STRUCTURAL SUBMITTAL REVIEW	
<input type="checkbox"/>	APPROVED
<input checked="" type="checkbox"/>	APPROVED AS NOTED
<input type="checkbox"/>	REVISE AND RESUBMIT
<input type="checkbox"/>	NOT APPROVED
<small>THORNTON TOMASETTI'S APPROVAL IS ONLY FOR GENERAL CONFORMANCE WITH THE DESIGN CONCEPT OF THE PROJECT AND GENERAL COMPLIANCE WITH THE INFORMATION GIVEN IN THE CONTRACT DOCUMENTS. ANY ACTION SHOWN IS SUBJECT TO THE REQUIREMENTS OF THE CONTRACT DOCUMENTS. THE CONTRACTOR IS SOLELY RESPONSIBLE FOR DIMENSIONS AND QUANTITIES WHICH SHALL BE CONFIRMED AND CORRELATED AT THE JOB SITE. FABRICATION PROCESSES AND TECHNIQUES OF THE CONSTRUCTION, COORDINATION OF THEIR WORK WITH THAT OF ALL OTHER TRADES AND THE SATISFACTORY PERFORMANCE OF THEIR WORK. THIS REVIEW DOES NOT BROADEN OUR SCOPE OF SERVICES OR ELEVATE THE APPLICABLE STANDARD OF CARE.</small>	
Thornton Tomasetti	
BY: <u>ALJG</u>	DATE: <u>10/15/2025</u>

1	For Approval	10/02/2025
REV	DESCRIPTION	DATE
FABRICATOR:  368 Ocean Avenue Lynbrook NY 11563		JOB No.
PROJECT NAME: 150 5TH AVE 150 5TH AVE, NY 10011		
TITLE: SIDEWALK VAULT FRAMING PLAN		
SHOP NOTES: - STEEL: ASTM A992 U.O.N. - FITTINGS: ASTM A 36 U.O.N. - TUBE: A500 GR B U.O.N. - PIP

SIDEWALK VAULT FRAMING PLAN
SCALE 1/4" = 1'-0"

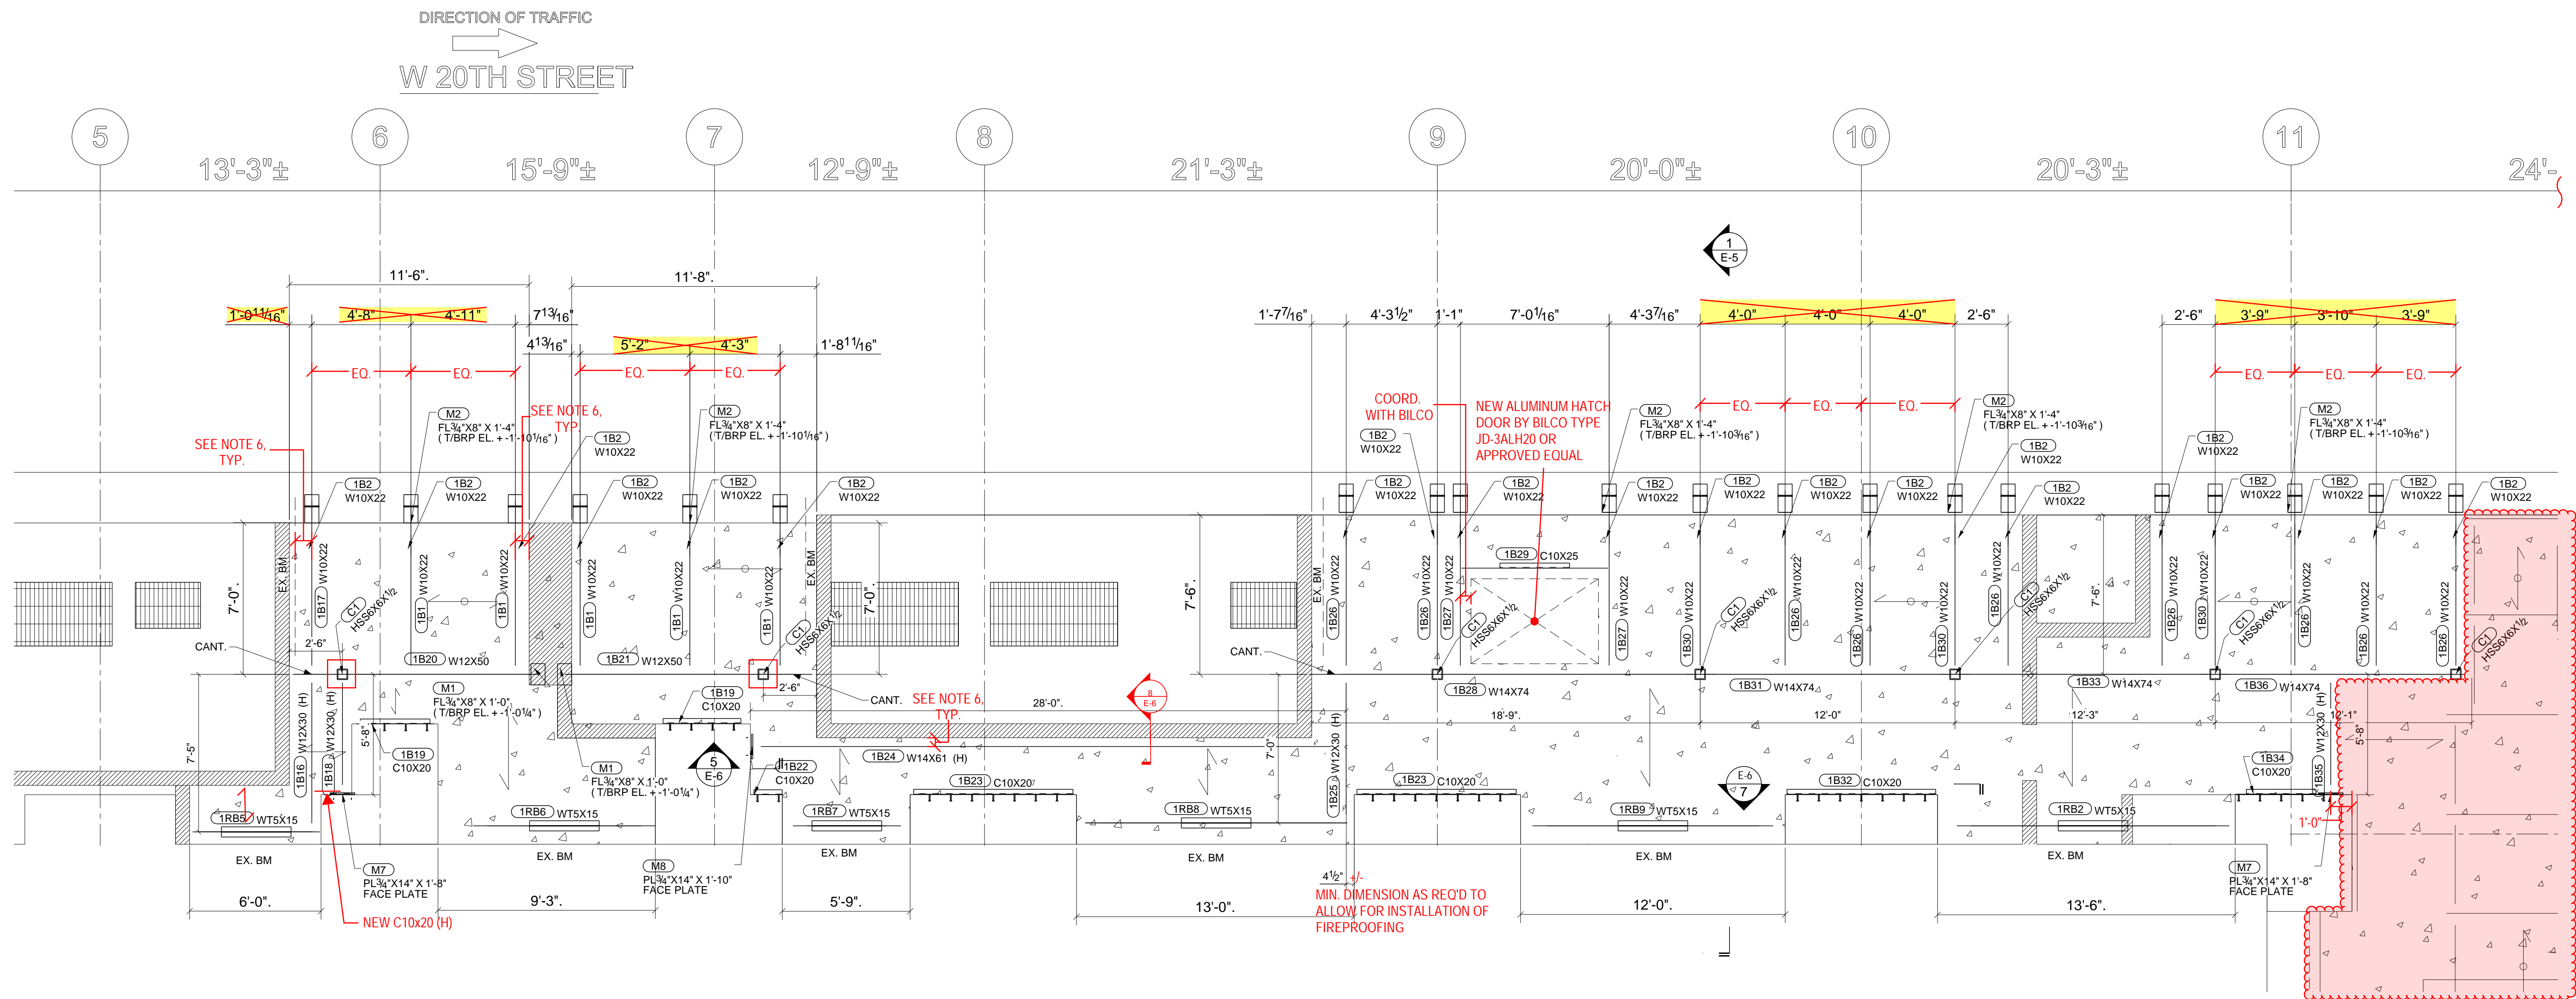
TT NOTES:
1. FABRICATION TO PROCEED ONCE FIELD VERIFICATION OF DIMENSIONS AND CONDITIONS IS COMPLETE.

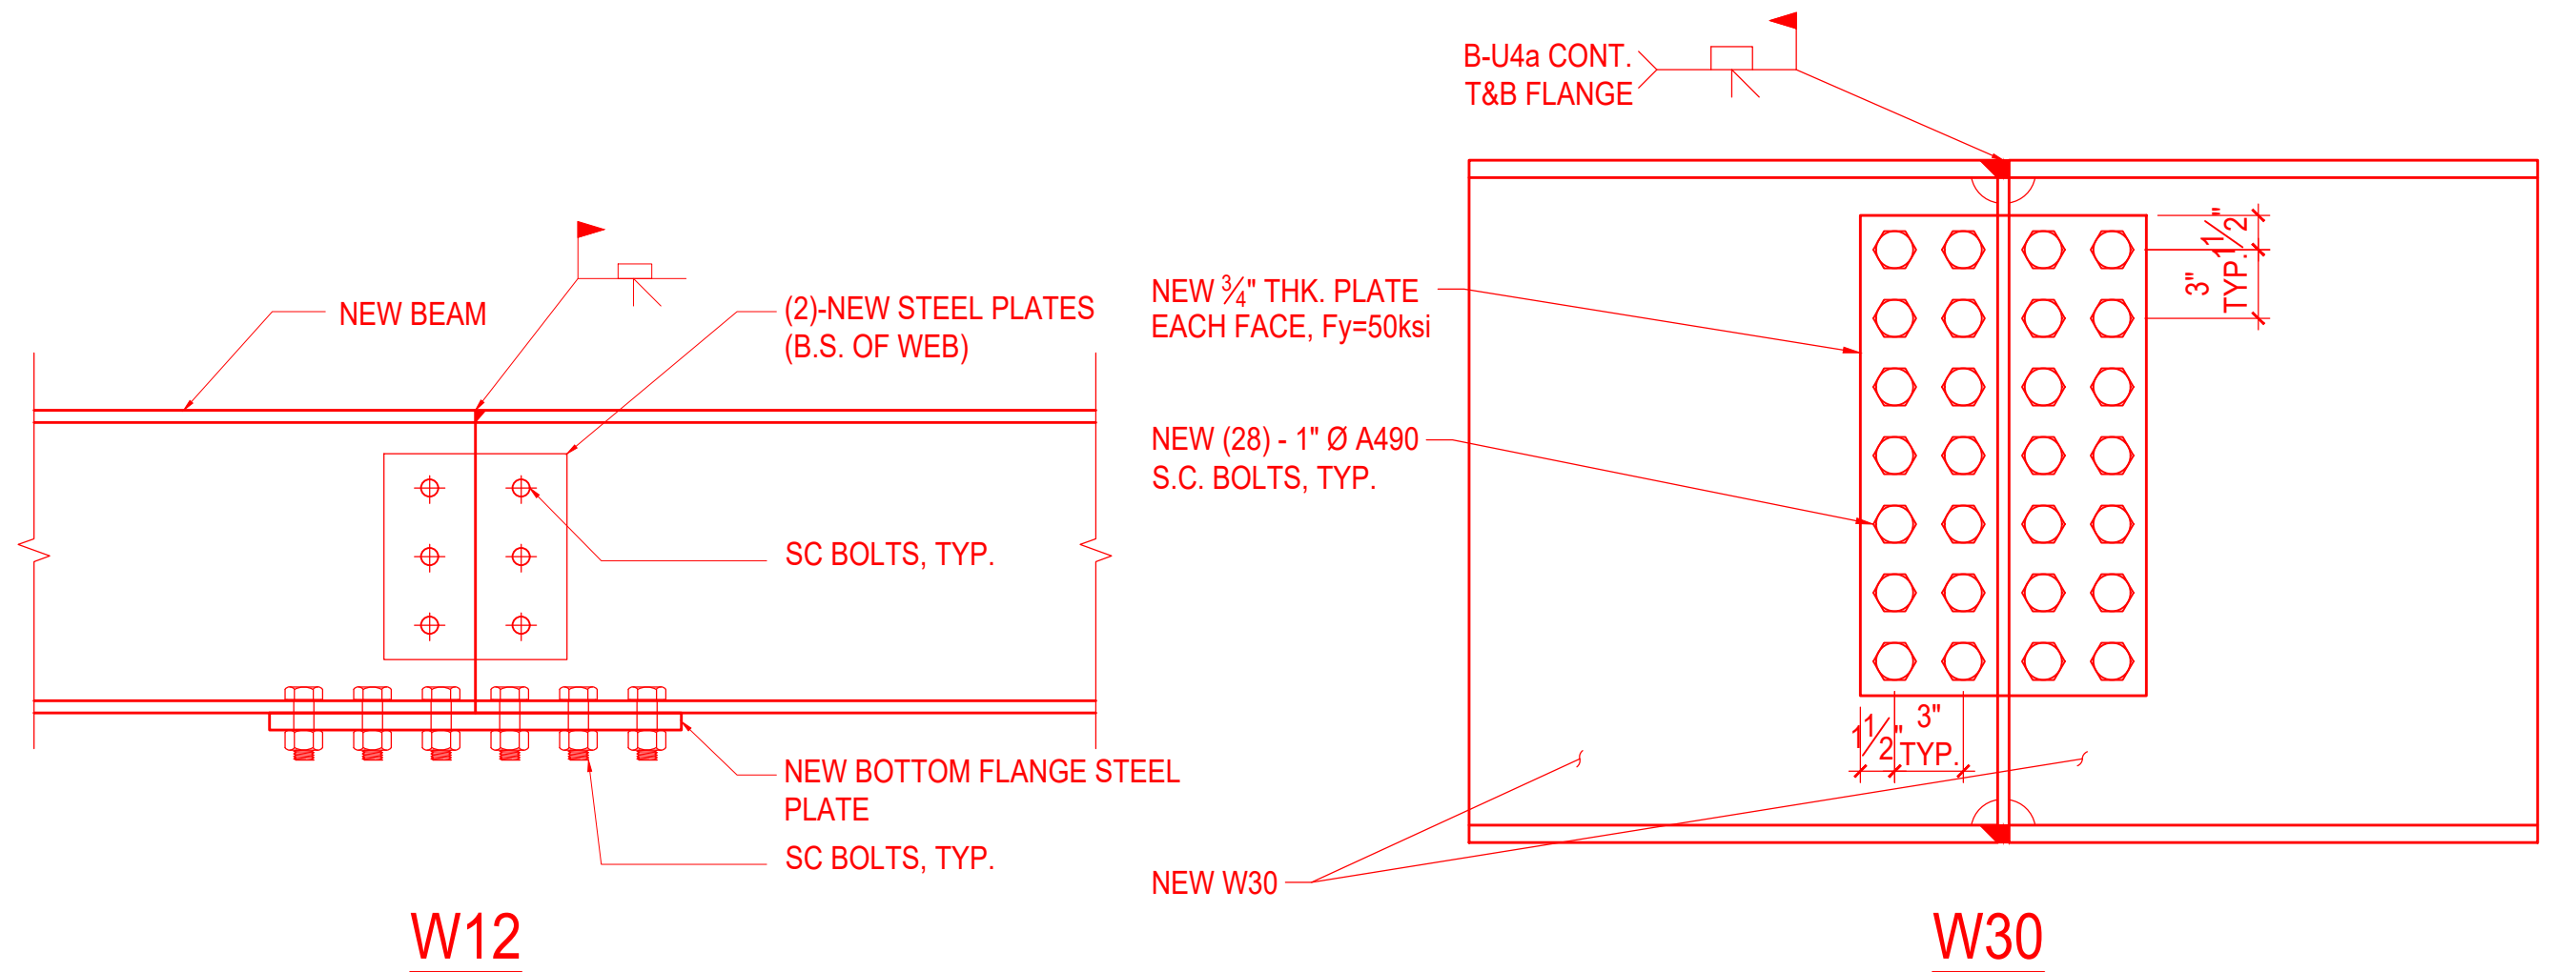
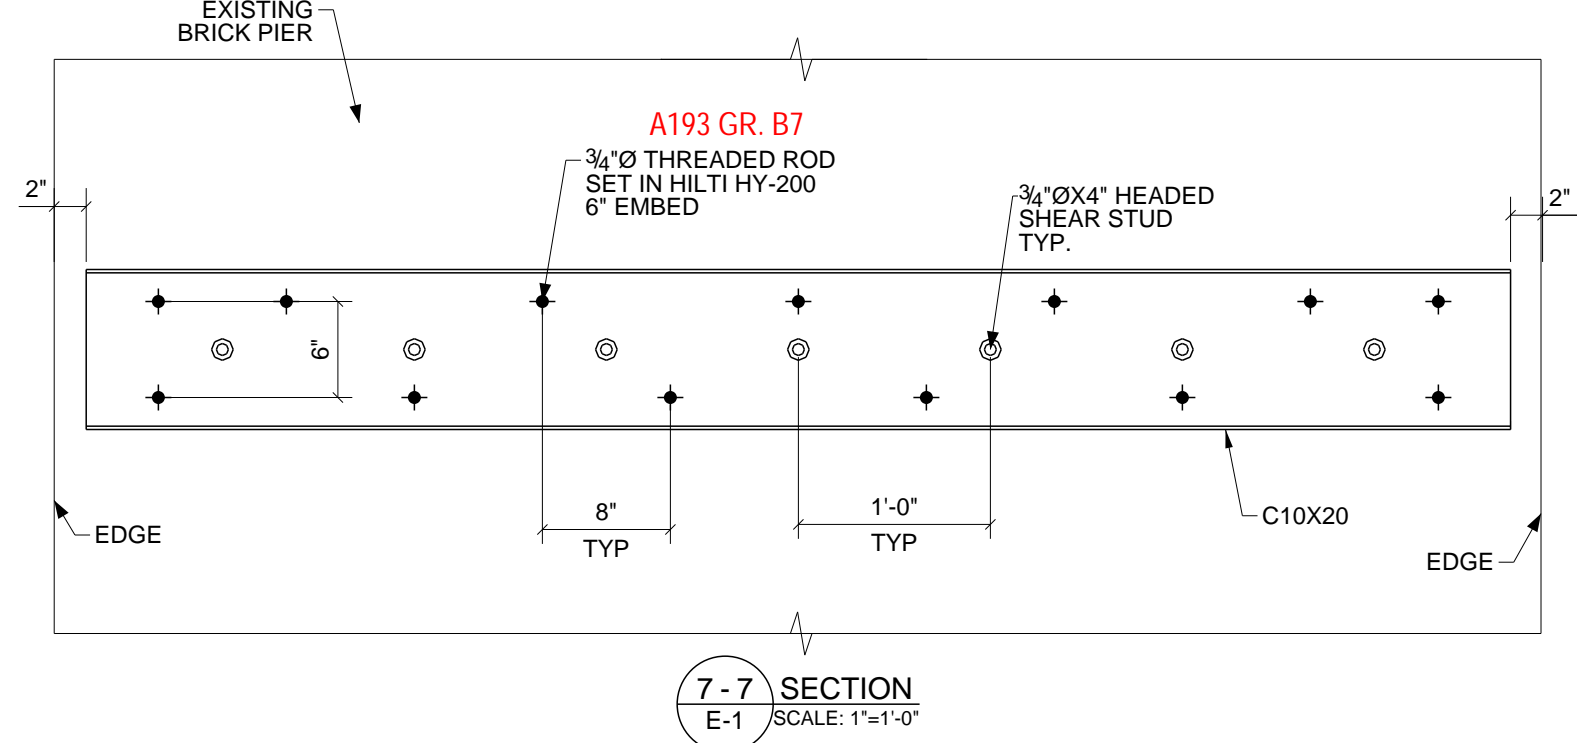
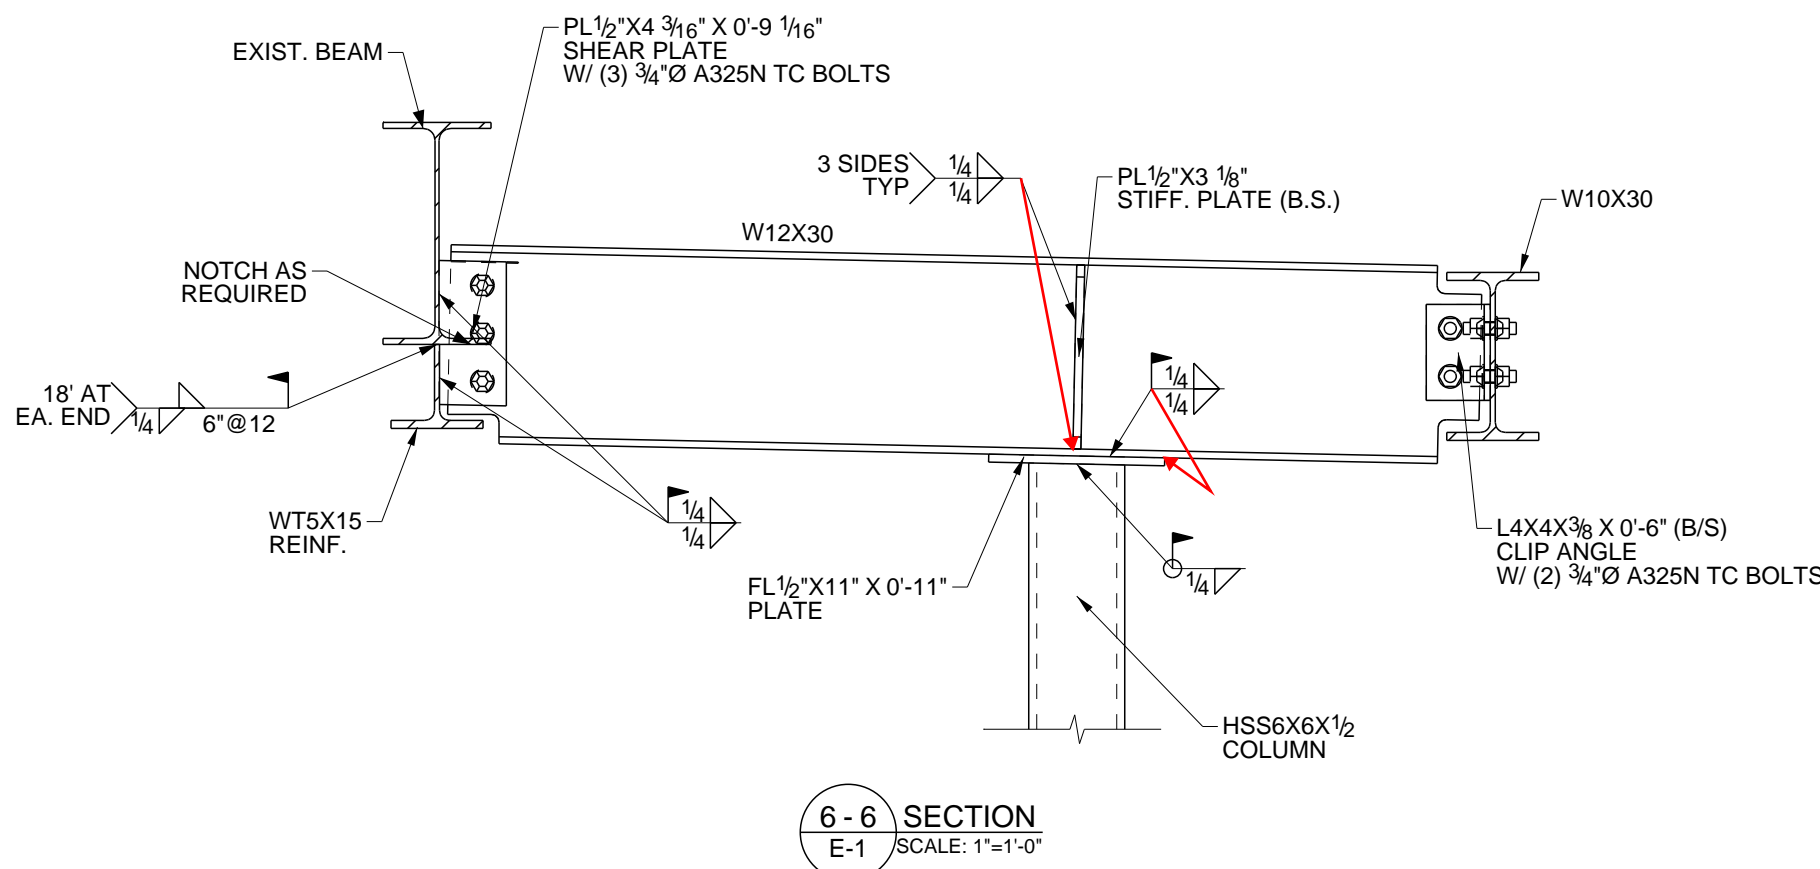
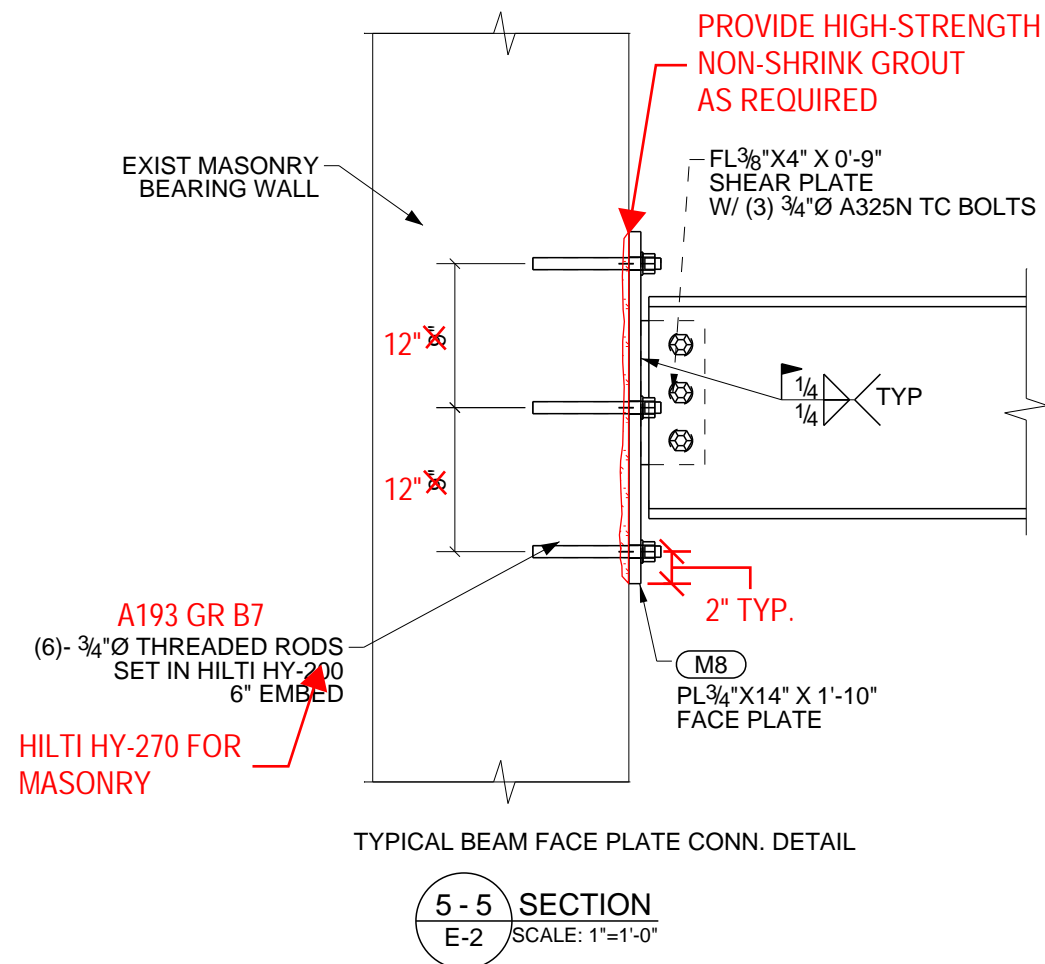
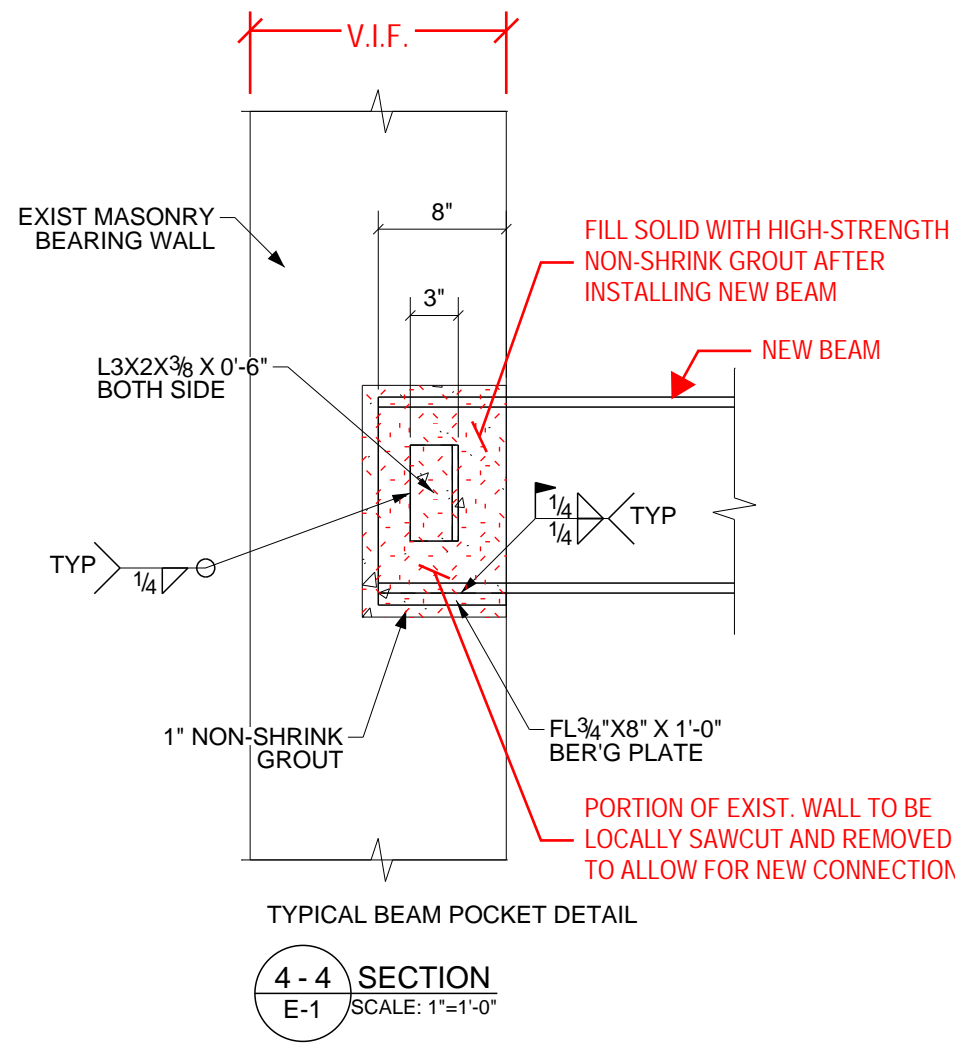
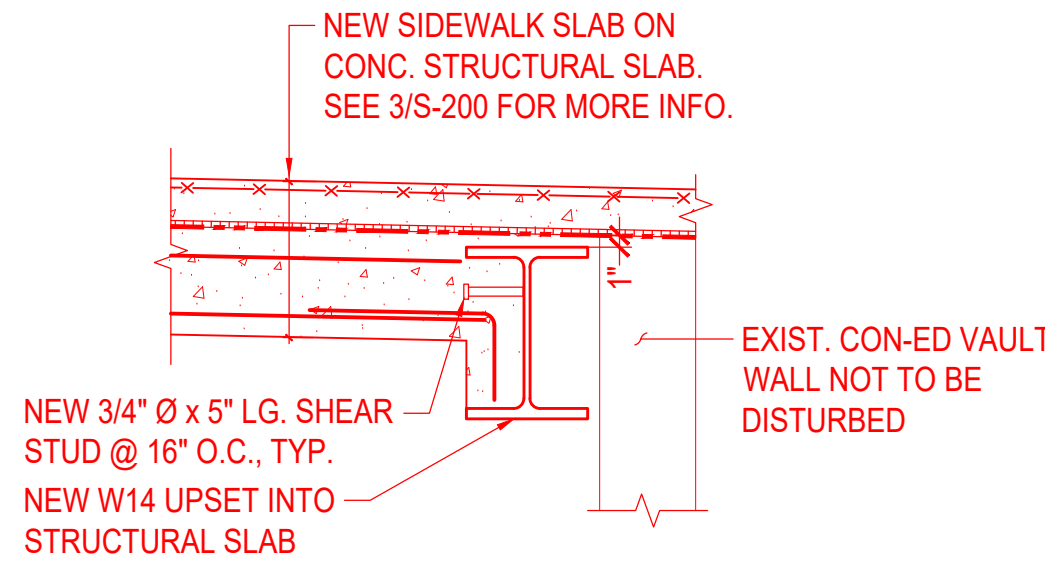
NOTE: LOCATE BEAM SPLICES MINIMUM 2'-0" FROM NEW POST LOCATIONS AND NEW INFILL BEAM CONNECTIONS.
